Objection submission COM/2019/81 -

Extractive Industry Development Code - 9.3.8 -

'Extractive Industry' development code requirements

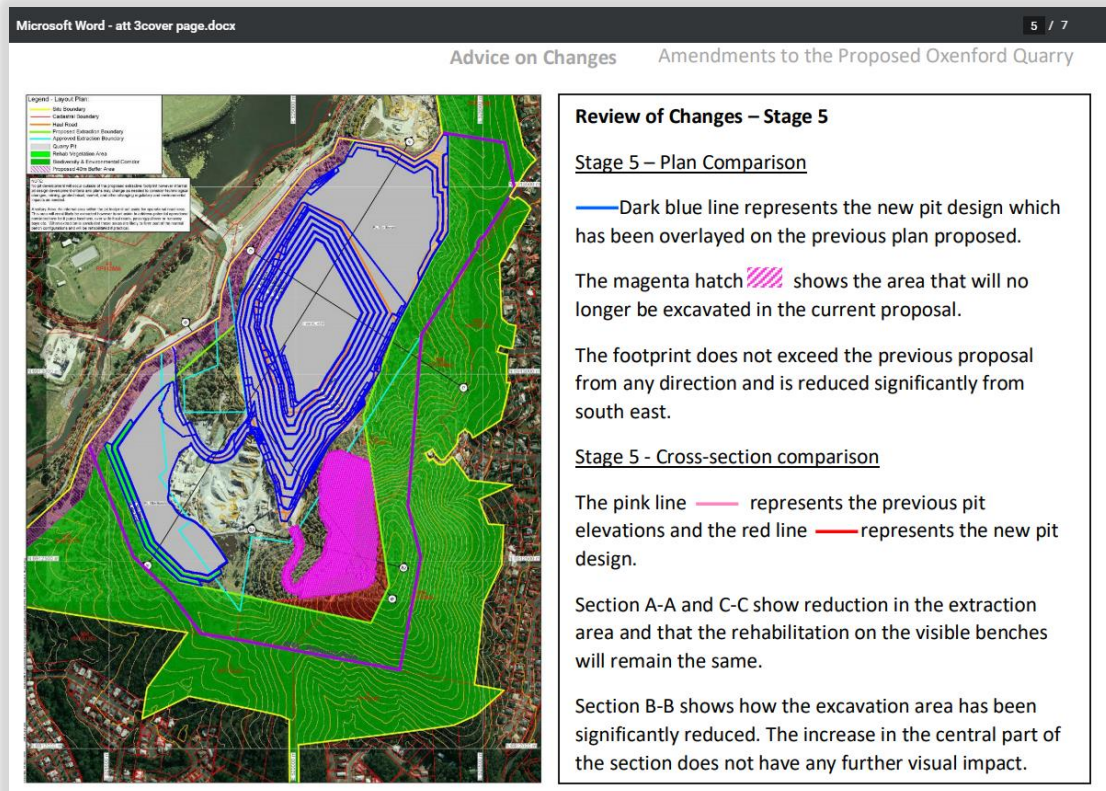
The recently submitted *'Attachment 3 - Revised Visual Assessment'* document (viewable on PDonline February 2021) dated 17<sup>th</sup> December 2020 shows the *'Stage 1 - Plan Comparison'* in which the proposed extractive footprint has encroached into the required 40m separation buffer (reproduced in Attachment B1).

*\* Please note red circle added for clarity.*

As can be clearly seen it is coloured light green which according to the key is: *'Rehab Vegetation area'*. Thereby seemingly conveniently skipping the highly visible development phase!

A detailed look at *'Attachment 3 - Revised Visual Assessment'*, *'Stage 1 - Plan Comparison'* shows that this area is within approximately 28 metres of the boundary (Close up of attachment B1, reproduced in attachment C1 for clarity). Clearly well within the *'Acceptable Outcome AO3.1'* which states: *"Extraction or processing activities are not conducted within 40m of any boundary of the site"* (Attachment A1).

Attachment C2 - 'Attachment 3 - Revised Visual Assessment', 'Stage 5 - Plan Comparison' close-up

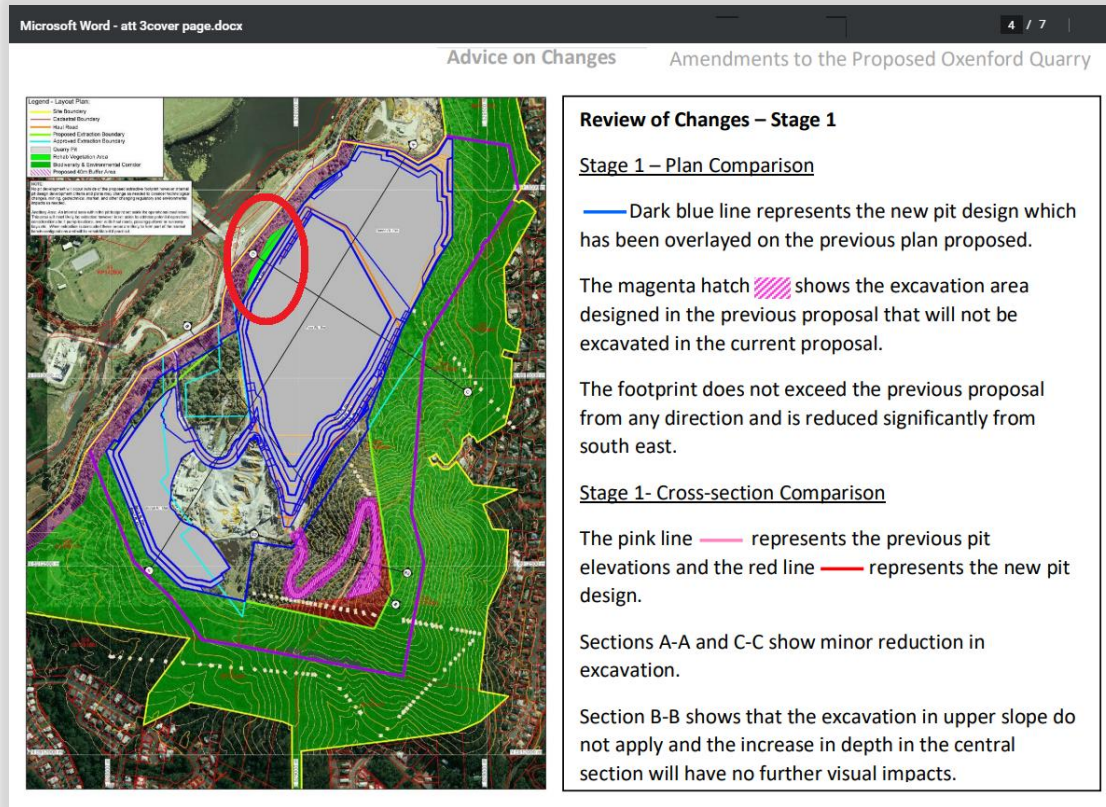
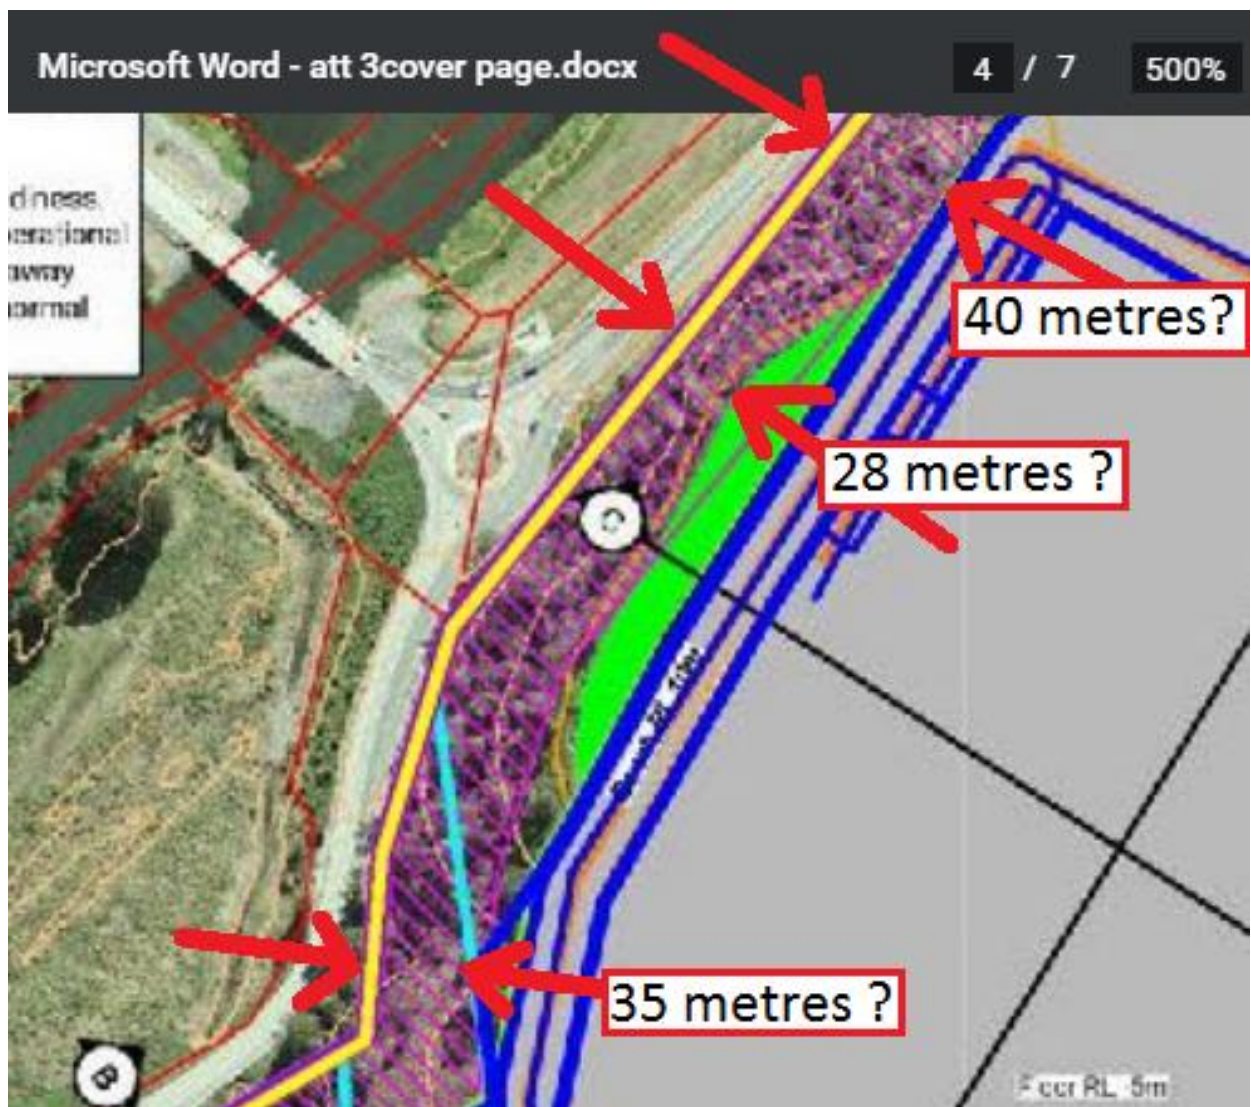
However, by page 5 of the *'Attachment 3 - Revised Visual Assessment'* document, the *'Stage 5 - Plan Comparison'* this *'Rehab Vegetation area'* has now become *"Quarry Pit"* (Attachment B2).

Similarly, a detailed look at *'Attachment 3 - Revised Visual Assessment'*, *'Stage 5 - Plan Comparison'* shows this area, that is within approximately 28 metres of the boundary, as *'Quarry Pit'* (Close up of attachment B2 reproduced in attachment C2). Clearly, again, contra to: *'Acceptable Outcome AO3.1'* which states: *"Extraction or processing activities are not conducted within 40m of any boundary of the site"* (Attachment A1).

Attachment D1 - 'Section 3.1 Proposal Pics': 'Regional Ecosystem Map'

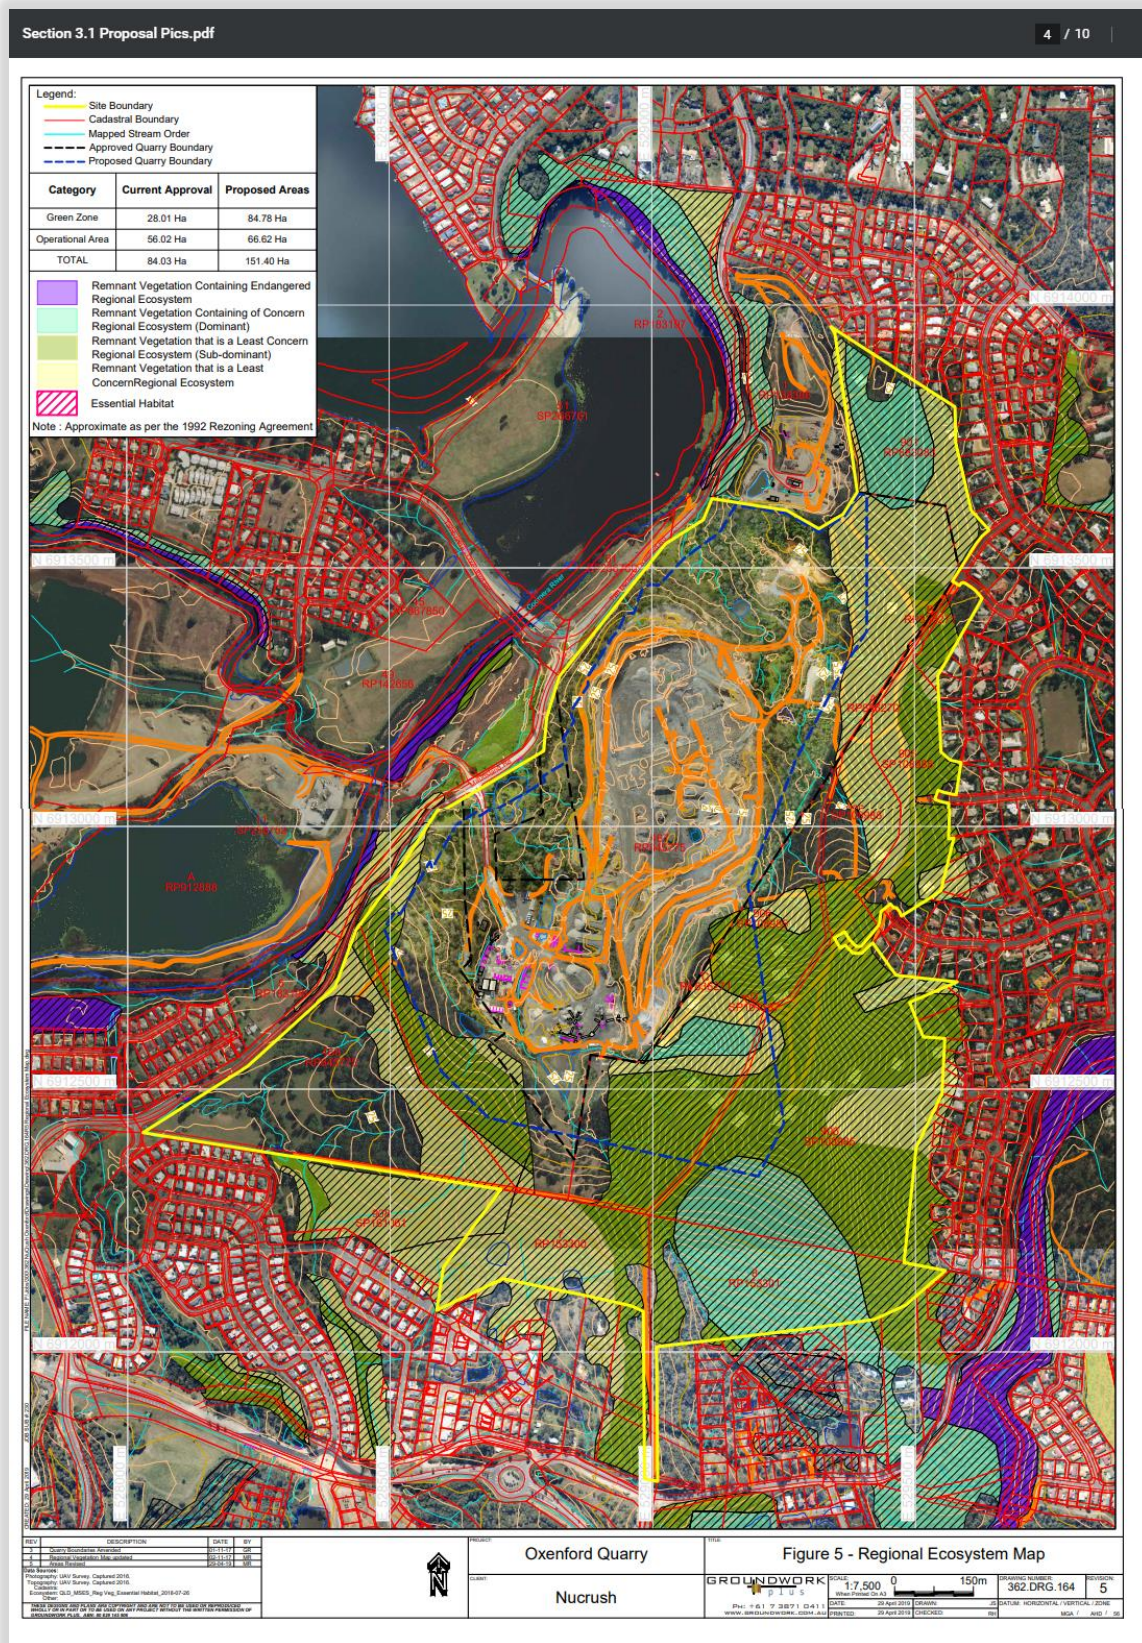
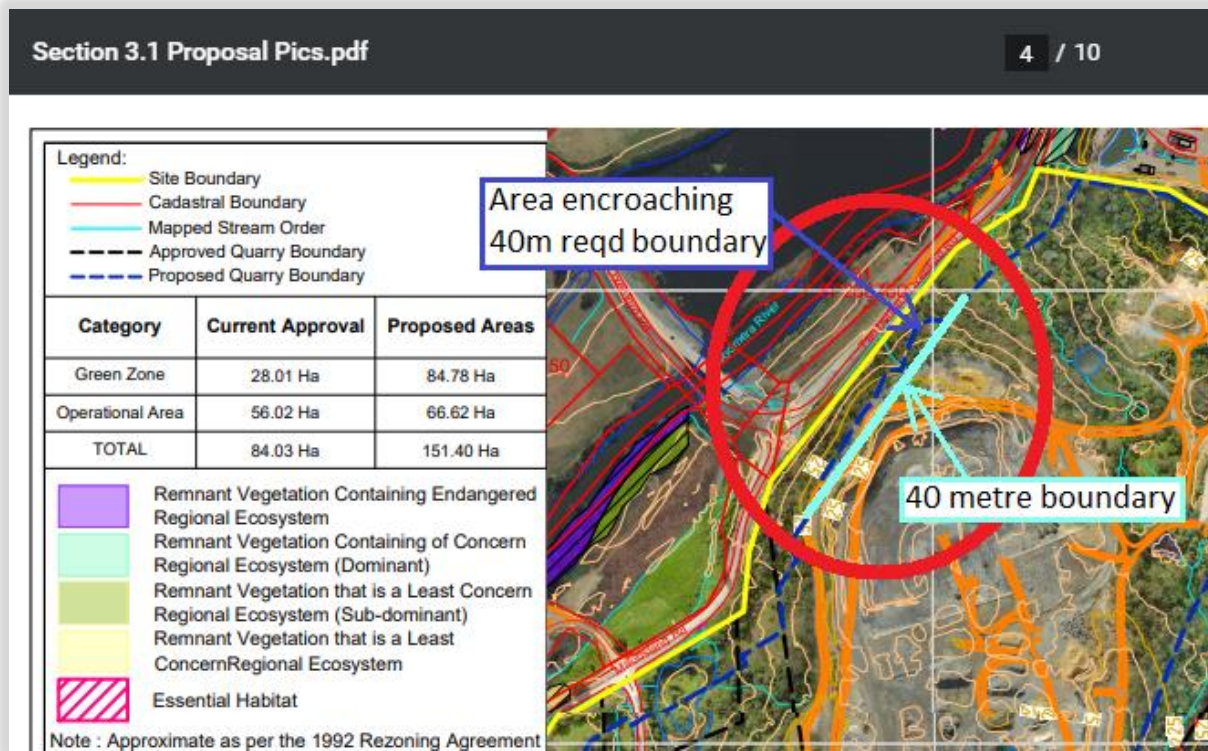
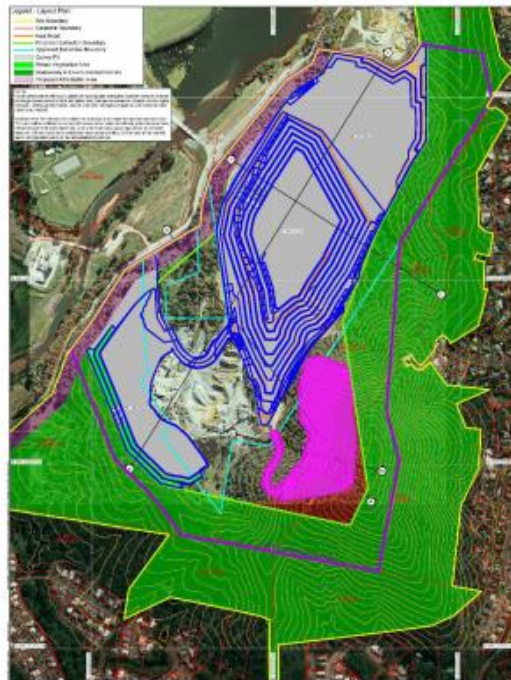
This can again also be readily witnessed in the *'Section 3.1 Proposed Pics'* document: *'Figure 5 - Regional Ecosystem Map'* where the *'Proposed Quarry Boundary'* can clearly be seen as encroaching with 40 metres of the boundary (reproduced in attachment D1, close up in attachment D2). Clearly, again, contra to: *'Acceptable Outcome AO3.1'* which states: *"Extraction or processing activities are not conducted within 40m of any boundary of the site"* (Attachment A1).

The applicant's claims that the *'Currently approved'* extractive footprint is *'56.02 ha'* as opposed to *'23.77 ha'* (and therefore only an 18% increase in area as opposed to what I believe is actually nearly three times the area) is re reiterated in attachment D1 and D2.

Figure 3 - Comparison of plans and cross-sections for Stage 5.

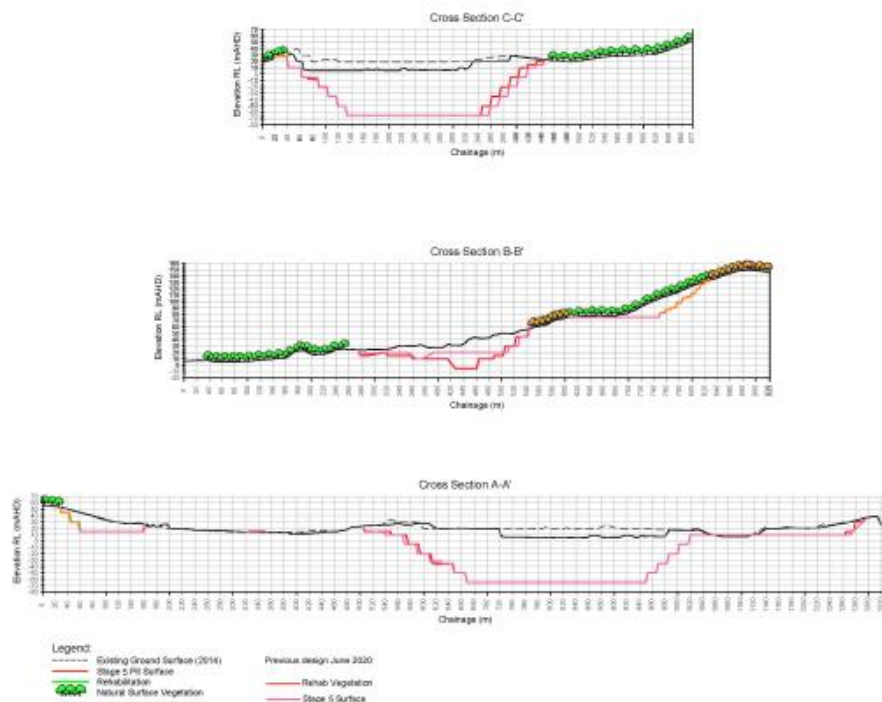
The whole of the '*Stage 5 - Plan Comparison*' page is shown in attachment E1 for reference.

I note on this page '*Stage 5 - Plan Comparison*' there is a Cross-Sections produced by the applicant. And, '*Cross Section C-C*' passes straight through the area in question (this is reproduced in attachment E2).

Unfortunately, the area in question does not appear to be a comprehensively shown in this cross section and maybe inaccurately shown for this area so I have endeavoured to produce what I believe is a more accurate, more extensive cross section for this area (Attachment E3). This is based on contour diagram from the City Plan Interactive Map (Attachment E4).

It is noted that the submitted cross section unfortunately only shows within the boundary and does not show the wider picture. I believe this is maybe to hide a somewhat controversial quarry operation in this area.

I have assumed this area will be quarried to RL 10 metres as I believe is shown in the '*Visualisation Stage 5 - Layout Plan*' (attachment E5), however, the '*Cross Section C-C*' seems to indicate this will be plateaued at approximately RL 28 metres. If it is to be plateaued at RL10m then my diagram I believe is an accurate depiction of the area which is extremely worrying with respect to the closeness of the Tamborine -Oxenford Road and the very little ridge between the two to protect from dust, noise, etc. However, if the '*Cross section C-C*' is accurate then a more worrying problem emerges in that the bench will be 20 metres (well above the 15 metres that I believe is the maximum agreed).

# Attachment E5 - 'Visualisation Stage 5 - Layout Plan'

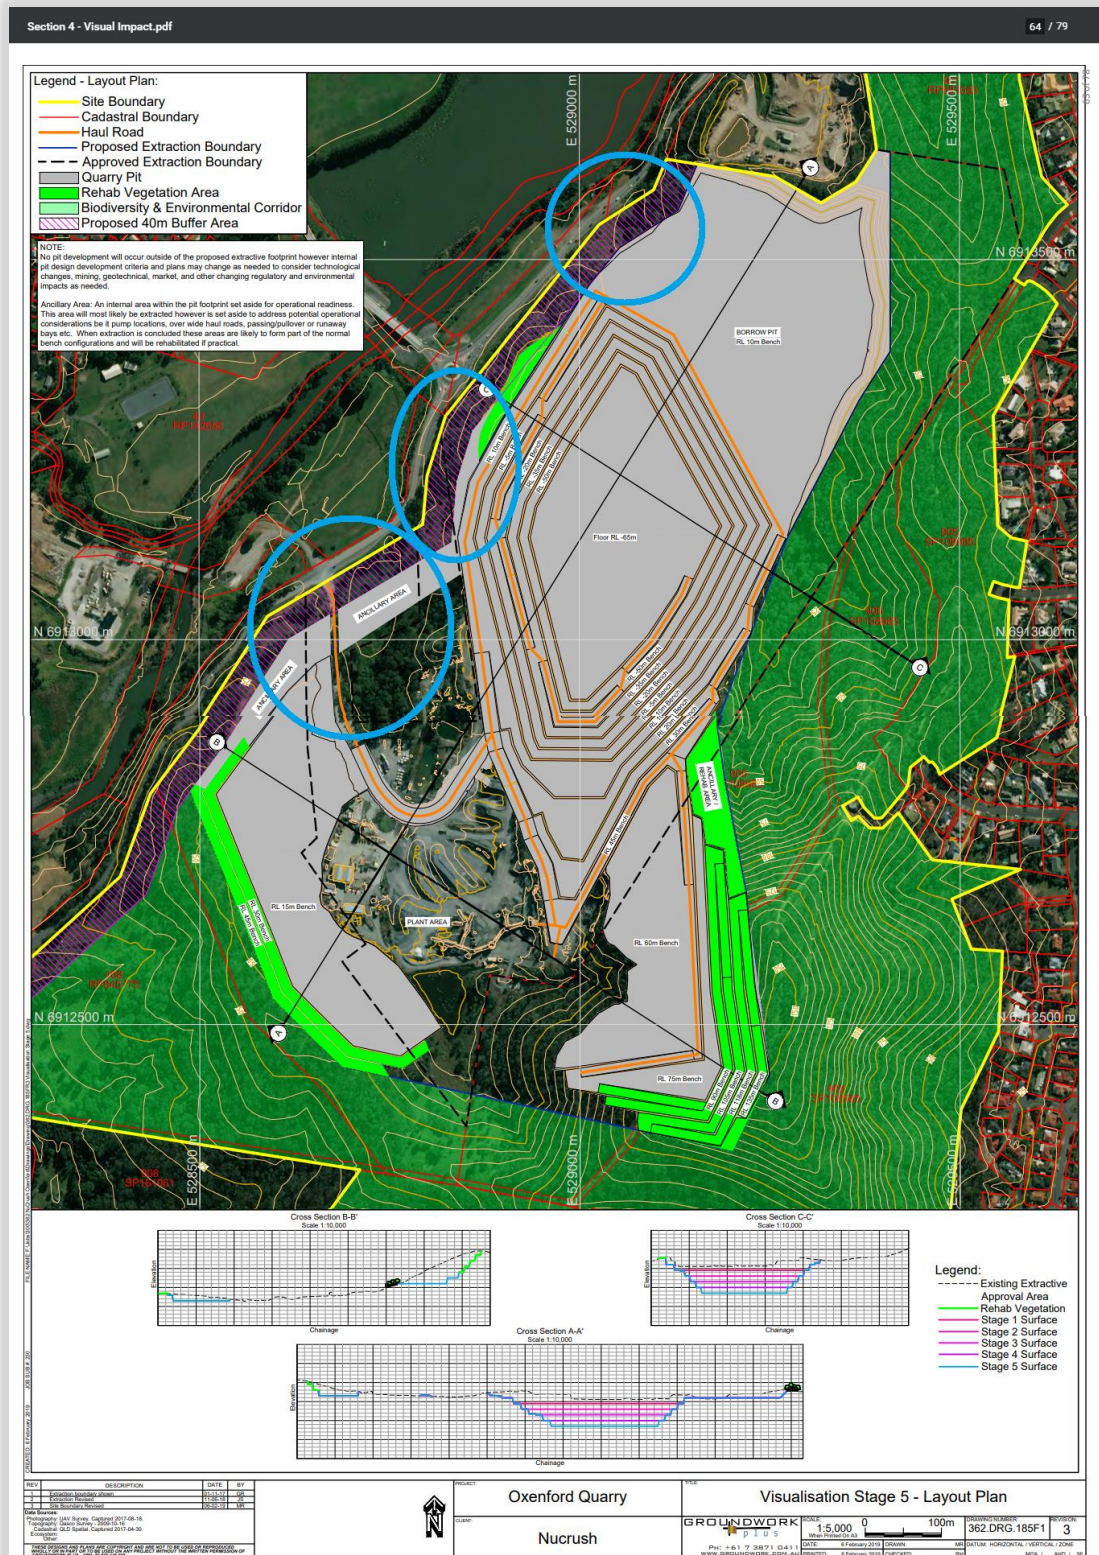
By Stage 5, the inner workings of the quarry will be, I believe, clearly visible from the Tamborine-Oxenford Road' and the 'Maudsland' Road' as indicated by the red arrows added to the: '*Visualisation Stage 5 - Layout Plan*' (reproduced in attachment E6). This will, I believe, include views of exposed benches, the processing plant, the haulage route and the truck parking areas (both north and south) which is contra to '*Acceptable Outcome AO3.2*' which states: "*Views of significant infrastructure and visually obtrusive development including quarry floors, benches and faces, are screened from the road frontage, major road corridors and adjoining residential areas*" (Attachment A1).
